WOODFORD MANUFACTURING BUILDING ADDITION
 2121 WAYNOKA RD, COLORADO SPRINGS, COLORADO 80915

SITE UTILITY PLAN

SITE GRADING & EROSION CONTROL PLAN

Markup Summary

SHEET: **U1.1**

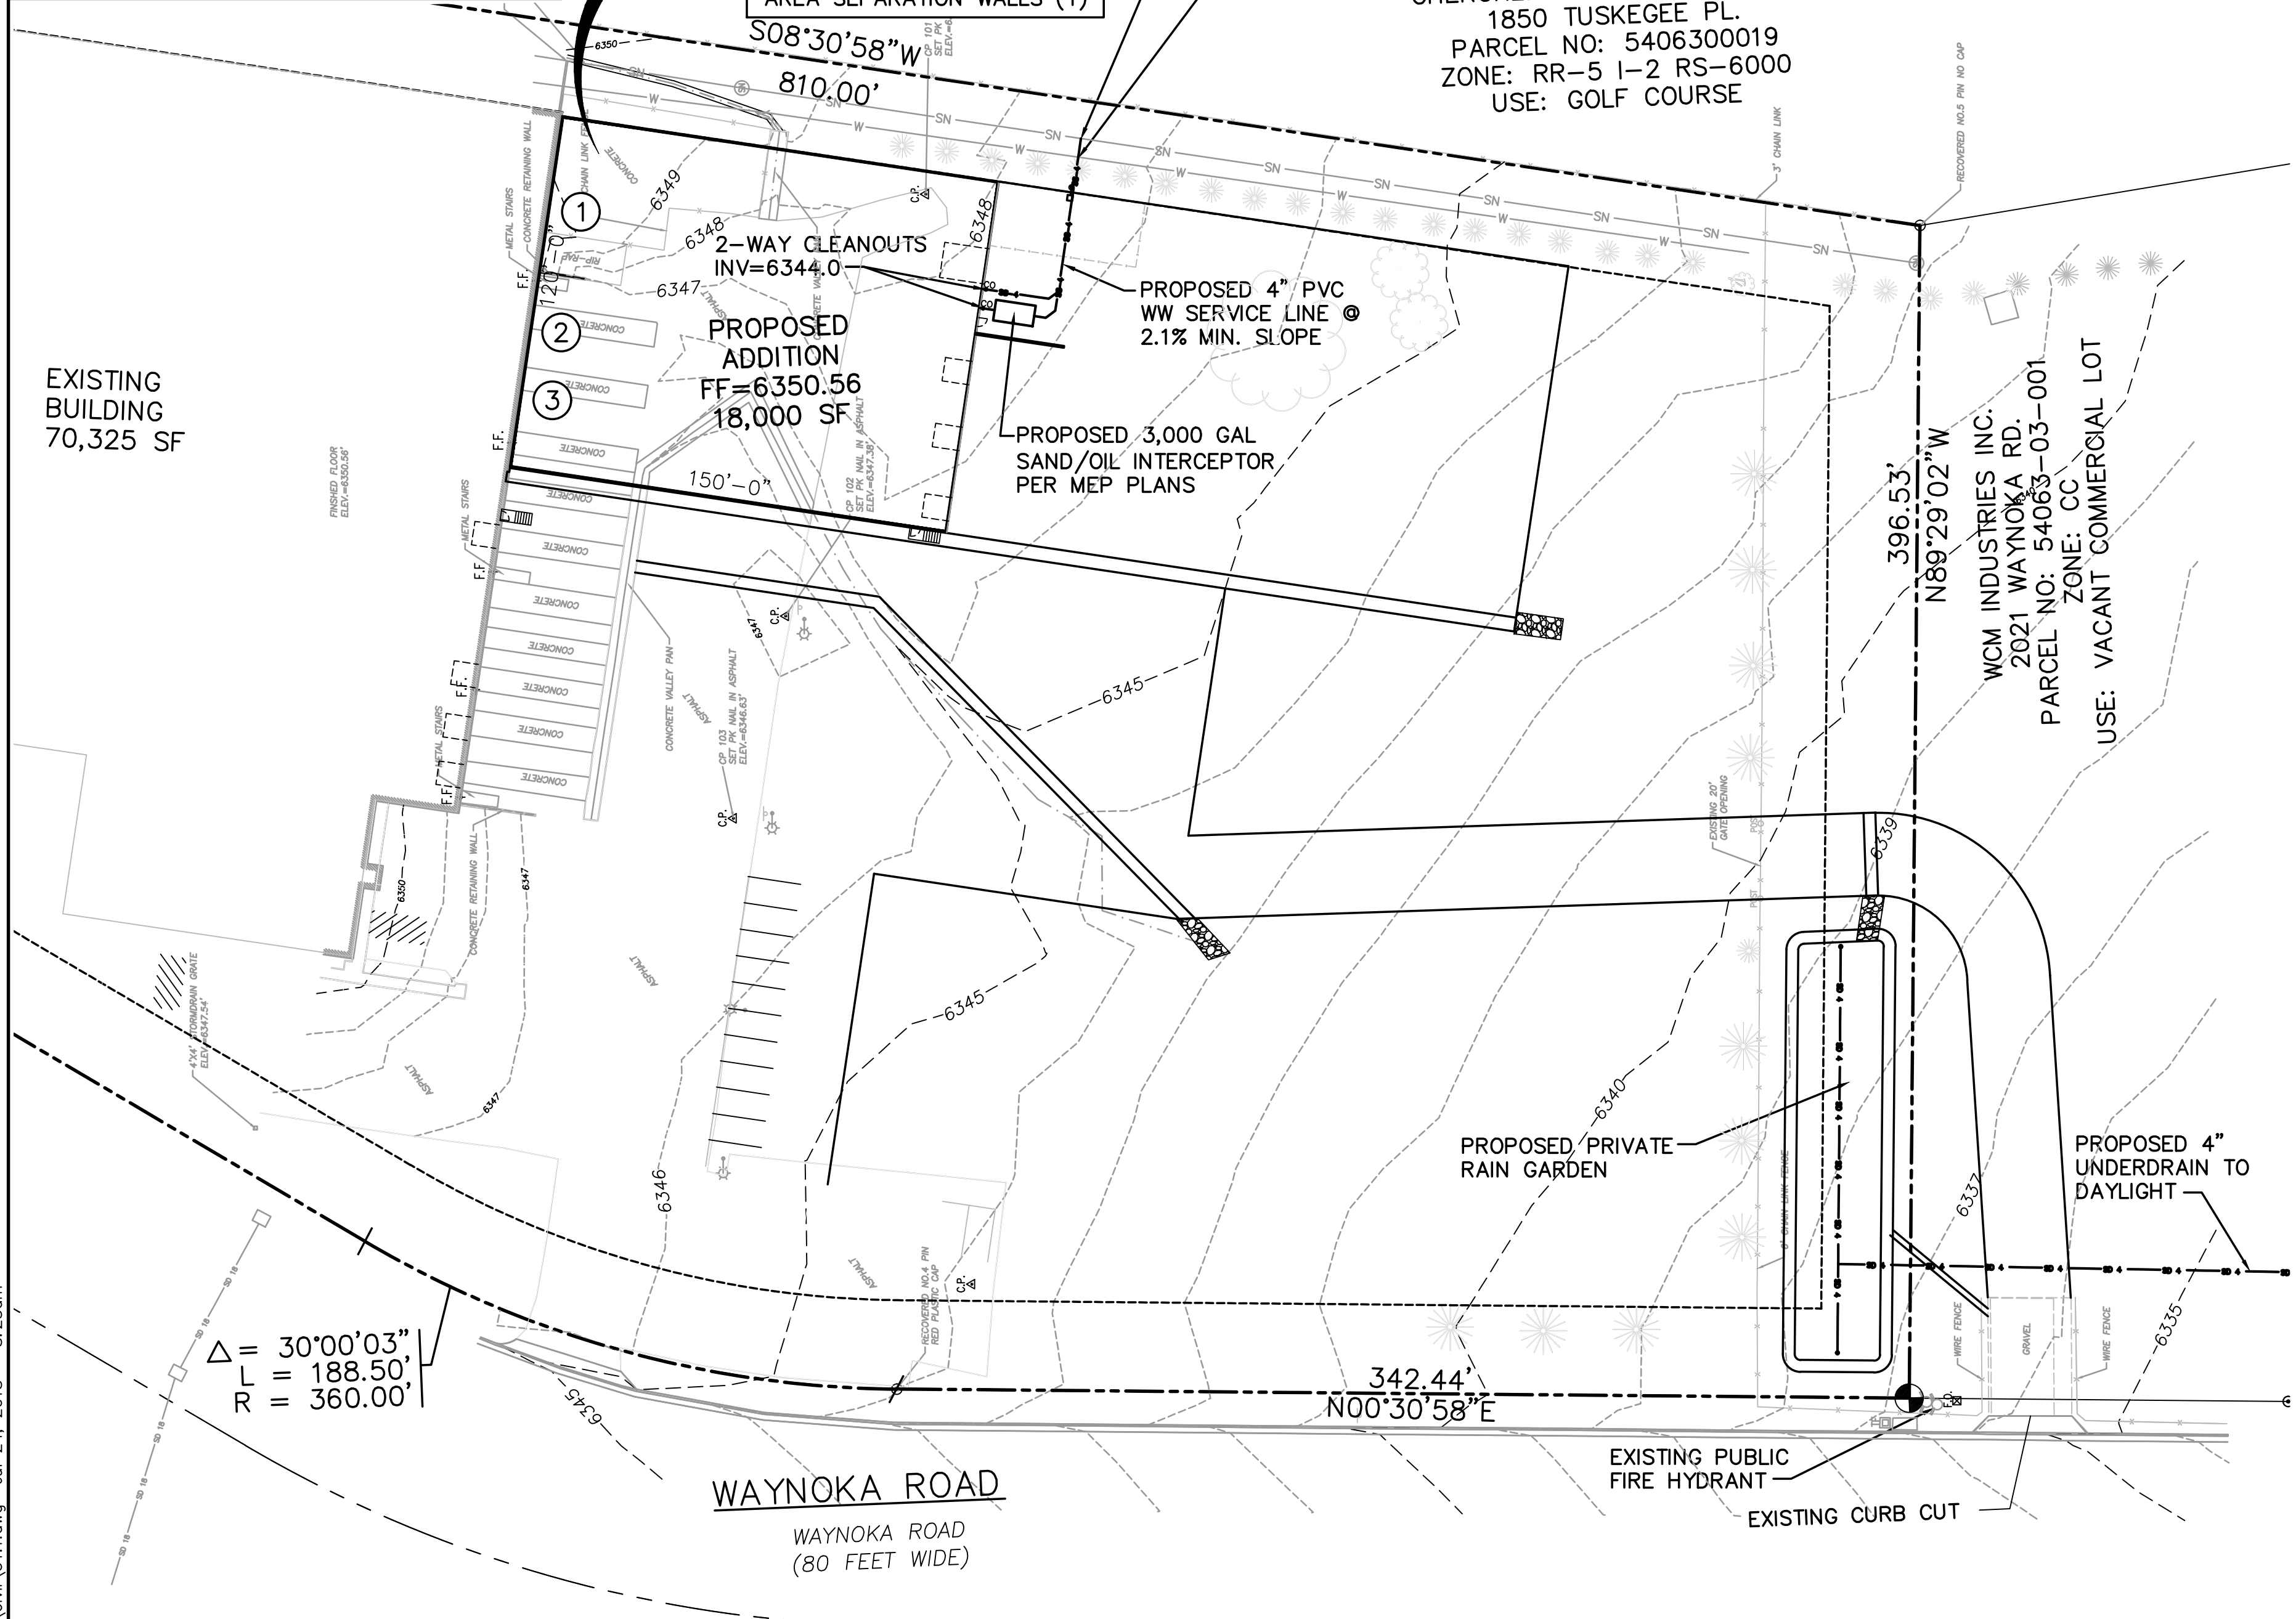
Remove the site utility plan from the standalone GEC and upload as a separate document.

C1.1

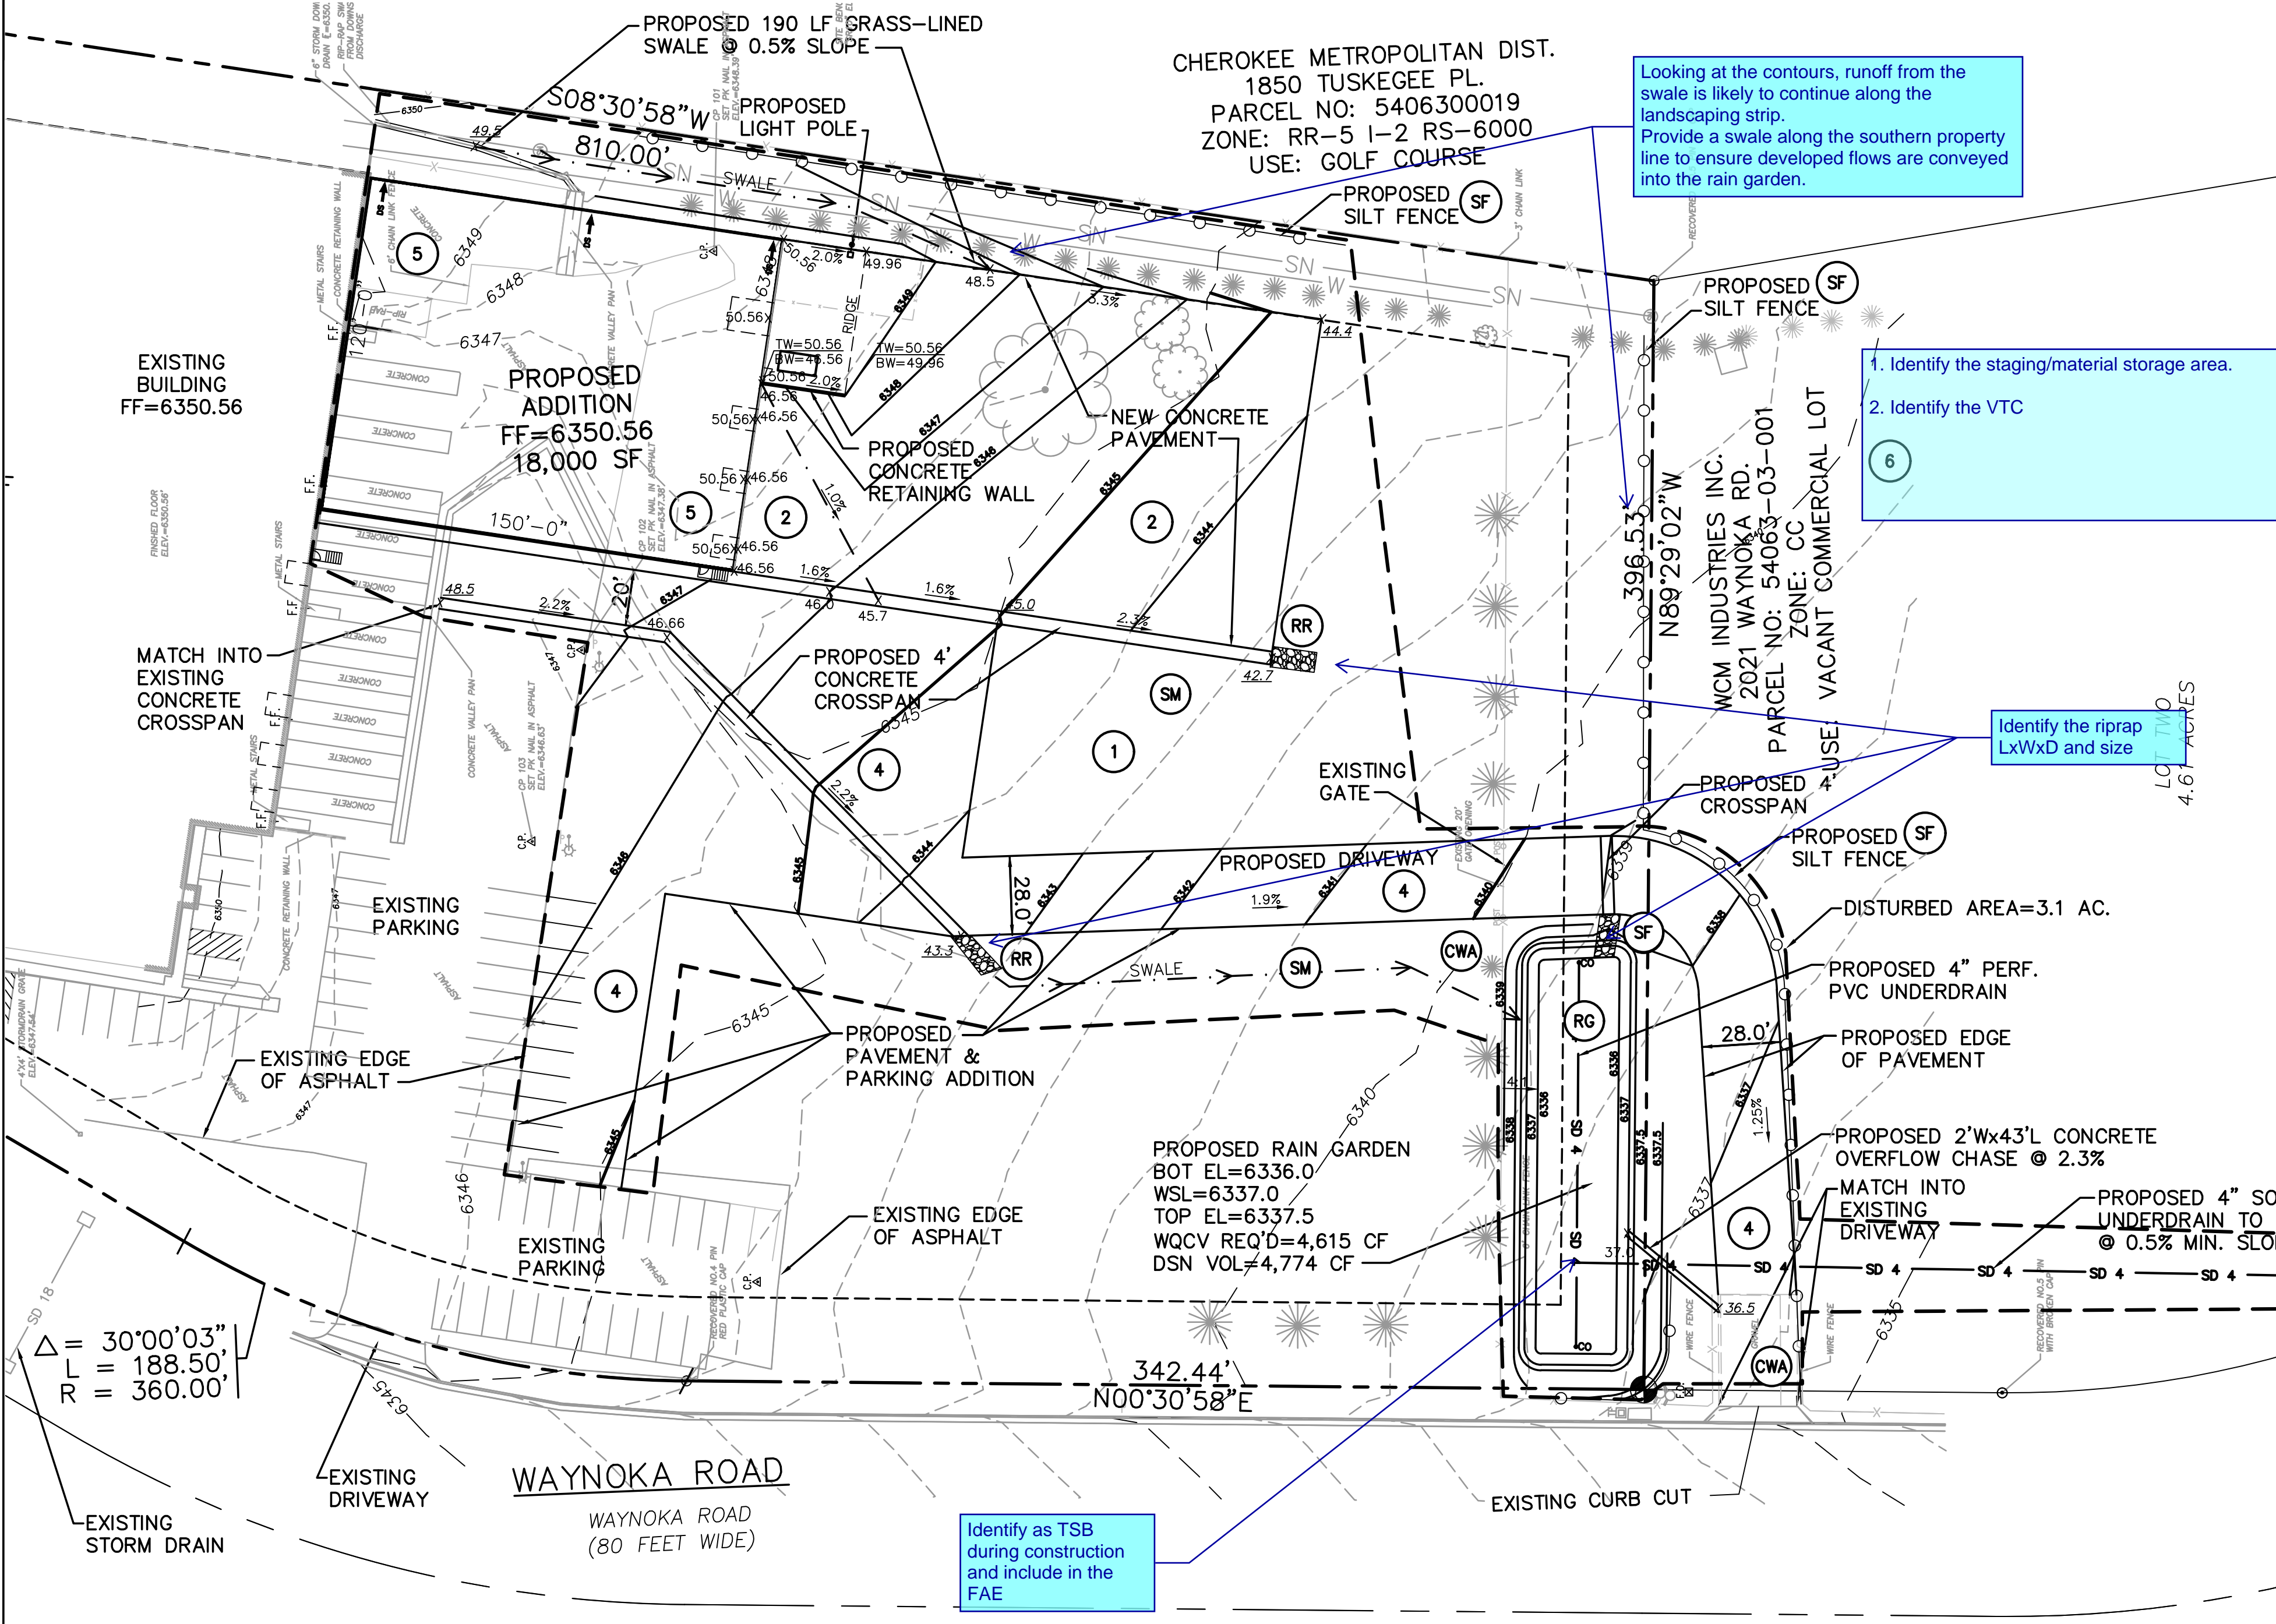
Add a sheet index for the standalone GEC plan.

Looking at the contours, runoff from the swale is likely to continue along the landscaping strip.
 Provide a swale along the southern property line to ensure developed flows are conveyed into the rain garden.

Identify the riprap LxWxD and size

Identify as TSB during construction and include in the FAE

-
1. Identify the staging/material storage area.
 2. Identify the VTC
